# UNITED STATES PATENT AND TRADEMARK OFFICE

APPLICATION NO.	FILING DATE	FIRST NAMED INVENTOR	ATTORNEY DOCKET NO.	CONFIRMATION NO.
10/802,899	03/16/2004	Shinichi Yamada	13869.28US01	4637

<b>Office Action Summary</b>	<b>Application No.</b>		<b>Applicant(s)</b>	
	10/802,899		YAMADA, SHINICHI	
	<b>Examiner</b>		<b>Art Unit</b>	
	Lan Nguyen		3683

## DETAILED ACTION

【圖 2】

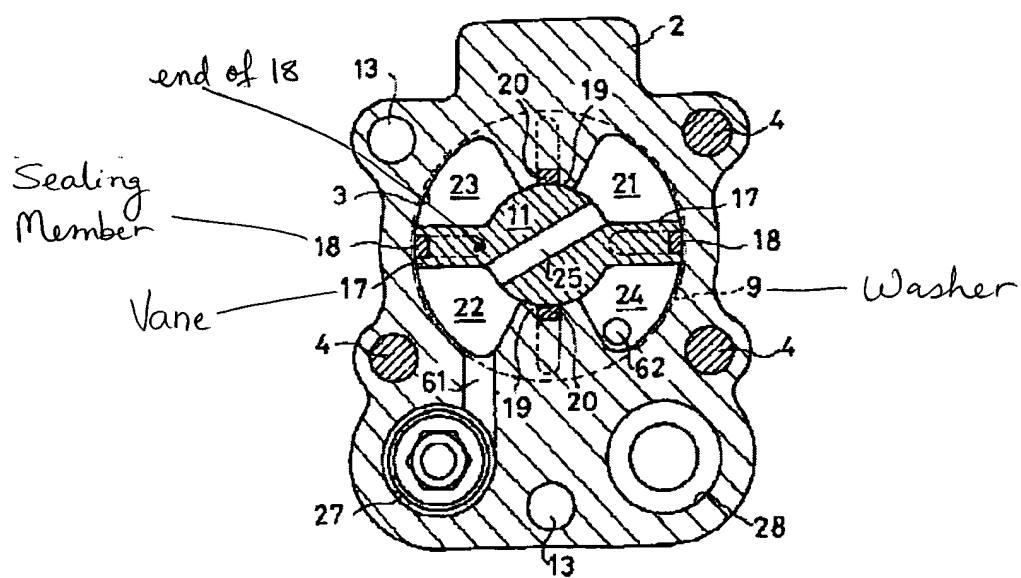
Re: claim 1, Yamamoto shows a rotary damper, as in the present invention, comprising: a housing 2, 5, 6; a fan-shaped oil chamber 22, 23 formed in the housing; a vane 17, on the left, dividing said oil chamber into two chambers 22, 23, a shaft 11 rotatably fastened to said housing and fixed to a base part of the vane such that said vane extends only in one direction, to the left, away from said base part; a seal part, as

described below, provided on said based part dividing in a fluid-tight manner between a bearing rotatably supporting said shaft on said housing and said two chambers, wherein the oil chamber generates a damping force by passing operation oil between said two oil chambers when said vane oscillates, said seal part comprises a pair of washers 9, 9, sandwiched between an inner face of the housing of said two chambers and the base part, as shown, and a sealing member 18 provided to at least portions of 3 edges of said vane which seals in a fluid-tight manner between said vane and the inner face of said housing; said sealing member having ends with the ends facing said base part of said vane contacting edge peripheries of said washers so as to seal in a fluid-tight manner therebetween, as marked below and as described in paragraph [0026] wherein the seal member 18 is to cover the sides and the end face of the vane 17 as shown in the figure below. Please note how the term "periphery" is being interpreted in the Response to Argument section below. Note also that each washer 9 is of a doughnut shape having an inner periphery and an outer periphery. As shown in figure 2, the ends of sealing member 18 contact the inner peripheries of washers 9, 9.

Re: claim 3, Yamamoto further discloses interconnected fitting grooves are formed in each part of said vane facing the inner face of said two chambers, and said sealing member is fitted and secured in said fitting grooves in page 3, paragraph [0026] and as illustrated in phantom lines in figure 2 above.

Re: claim 4, Yamamoto shows said base part to be located between said fitting grooves and said shaft in figure 2 with the phantom line on vane 17 representing the fitting grooves.

5. Applicant's argument is more specific than the claim language. Applicant argues that Yamamoto does not show a fan-shaped chamber and a vane extending only in one direction. Looking at figure 2 of Yamamoto, one can see clearly that the left portion of Yamamoto's damper shows the claimed fan-shaped chamber and vane 17 extending only to the left direction to divide the fan-shaped chamber into two chambers 22 and 23. Applicant has not provided any limitation in the claim to exclude a plurality of the claimed chamber and vane. Applicant also argues that Yamamoto's sealing member 18 does not contact the edge peripheries of the washers 9, 9. The definitions of the term "periphery" are provided below. Using definition #1 of the term "periphery" and definitions #1a, 1b and 2 of the term "perimeter", one can see that the ends facing the base part of sealing member 18 of Yamamoto contact the inner edge peripheries of washers 9, 9.
